# **A12 Chelmsford to A120 widening scheme**

**TR010060**

## **DEVELOPMENT CONSENT ORDER CHANGE APPLICATION CONSULTATION**

### **B1023 Flood Mitigation and Drainage Technical Note**

**Plate 3.1 New design proposals in comparison with design submitted in August 2022 in the vicinity of the B1023, near Inworth (Cluster Area 1)**

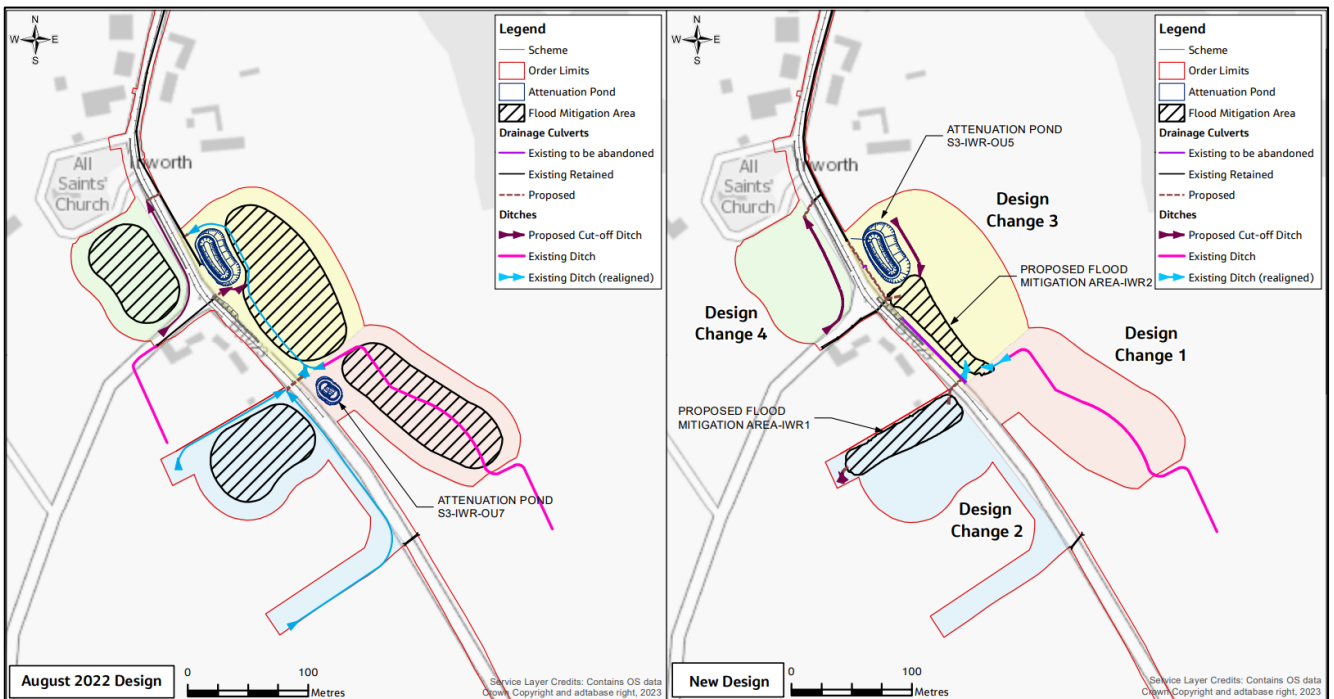
Landtake Area Reference from Plate 3.1	New Design Solution
Design Change 1	<p><b>Attenuation Pond S3-IWR-OU7 has been removed.</b> There are no highway widening works within the catchment S3-IWR-OU7 boundary. Hydraulic checks indicate minor increase in flows due to an increase in rainfall values for climate change allowance which will be manageable through localised upgrades to drainage collection features.</p> <p>The design submitted in August 2022 included a flood mitigation storage area that would have required excavation over the gas main, the location of which was unknown at DCO Stage design. New design has taken this constraint into account and developed the solution through hydraulic modelling that confirmed <b>removal of flood mitigation measures in this area.</b></p>
Design Change 2	<p><b>New drainage ditches adjacent to the B1023 near Inworth</b> that were considered previously as part of flood risk mitigation <b>are not required.</b></p> <p>New design proposal has considered the constraint imposed by existing the HP gas main and been informed by hydraulic modelling. <b>New design (proposed flood mitigation -IWR1) provides a reduction in the flood mitigation storage area requirements.</b></p>

Design Change 3	<p><b>Attenuation Pond S3-IWR-OU5 has been retained.</b></p> <p><b>New design proposal (proposed flood mitigation – IWR2)</b> has been informed through hydraulic modelling and <b>provides reduction in the flood mitigation storage area requirements.</b></p>
Design Change 4	<p>New design has been developed through hydraulic modelling which has confirmed <b>removal of flood mitigation measures in this area.</b></p> <p><b>Proposed drainage ditch is retained</b> although required to move further away from the road and enlarged to capture the overland runoff from the catchment upstream which forms part of the overall solution for flood mitigation measures in this area.</p>

**Plate 3.2 New design proposals in comparison with the design submitted in August 2022 in the vicinity of the B1023 near Inworth (Cluster Area 2)**

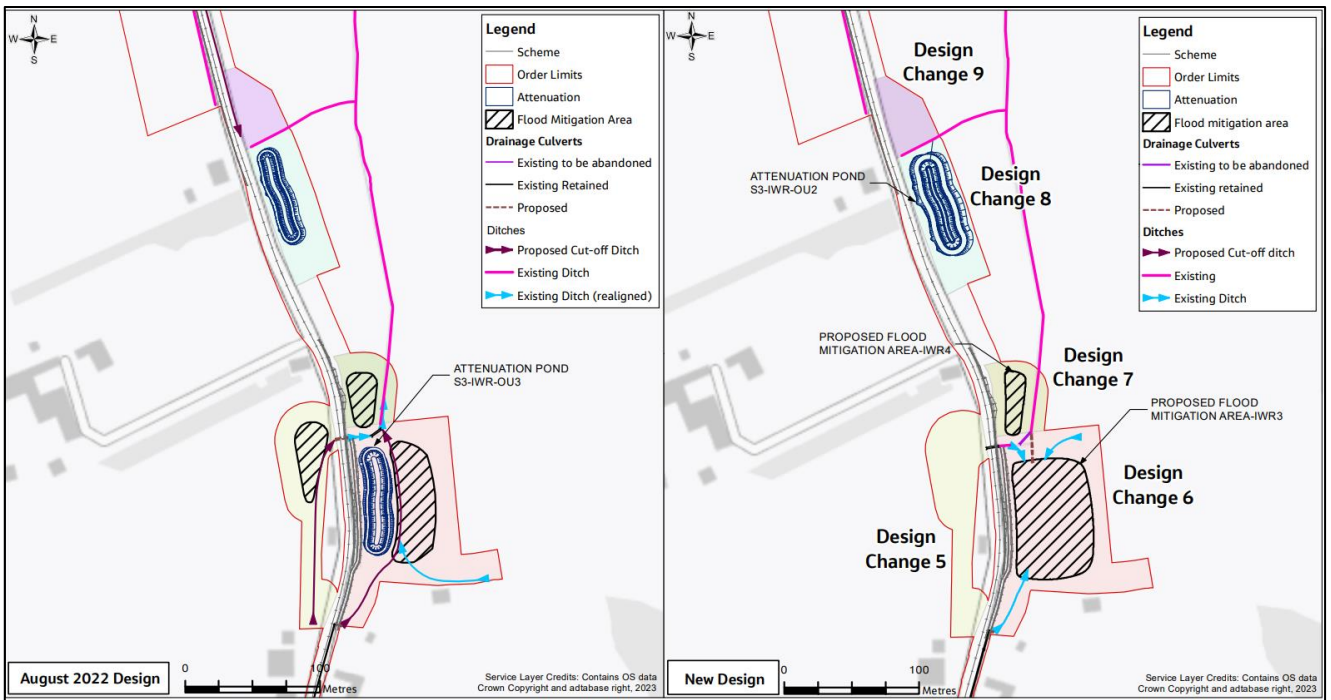
Landtake Area Reference from Plate 3.2	New Design Solution
Design Change 5	<p><b>New drainage ditch and flood mitigation storage area</b> adjacent to the B1023, near Inworth, that were considered for the design submitted at DCO <b>are not required</b>. Existing field drains/ditches found in the location of the new drainage ditch and will be retained.</p>
Design Change 6	<p>A new design solution has been developed to optimise the combined design solutions that would work for the mitigation required for the highway drainage (attenuation storage) and for the flood risk mitigation storage. <b>Attenuation Pond S3-IWR-OU3 has been removed</b> and the highway drainage catchment is now diverted to Attenuation Pond S3-IWR-OU2.</p> <p><b>Flood mitigation storage area (proposed flood mitigation area – IWR3)</b> has been informed through hydraulic modelling and has <b>increased in area (i.e. in comparison to the design submitted in August 2022 but is still within the Order Limits)</b>.</p>

Landtake Area Reference from Plate 3.2	New Design Solution
Design Change 7	<b>Flood mitigation storage area (proposed flood mitigation area – IWR4)</b> is proposed to be retained. Minor adjustments will be required to minimise the impact to the existing foul sewer in the area.
Design Change 8	<b>Attenuation Pond S3-IWR-OU2 is retained.</b> Note there has been an increase in the attenuation storage volume for Attenuation Pond S3-IWR-OU2 ( <b>i.e. in comparison to the design submitted in August 2022 but is still within Order Limits</b> ) as a result of the additional highway drainage catchment draining to this attenuation storage pond which was previously associated to Attenuation Pond S3-IWR-OU3 (i.e. Design Change 6). Attenuation Pond S3-IWR-OU2 has been adjusted locally to minimise the impact on the existing foul sewer located in this area.
Design Change 9	This area is considered as potential attenuation for the highway drainage for Catchment S3-IWR-OU1 that will be reduced in size as this catchment now drains through proposed Catchment S3-OU8B+OU8D. Refer to consultation Map Book 4, Sheet 20 of 21 of Drainage and Surface Water Plan for the revised catchments for the proposed S3-OU8B + OU8D catchments that includes the diverted existing S3-IWR-OU1 catchment.
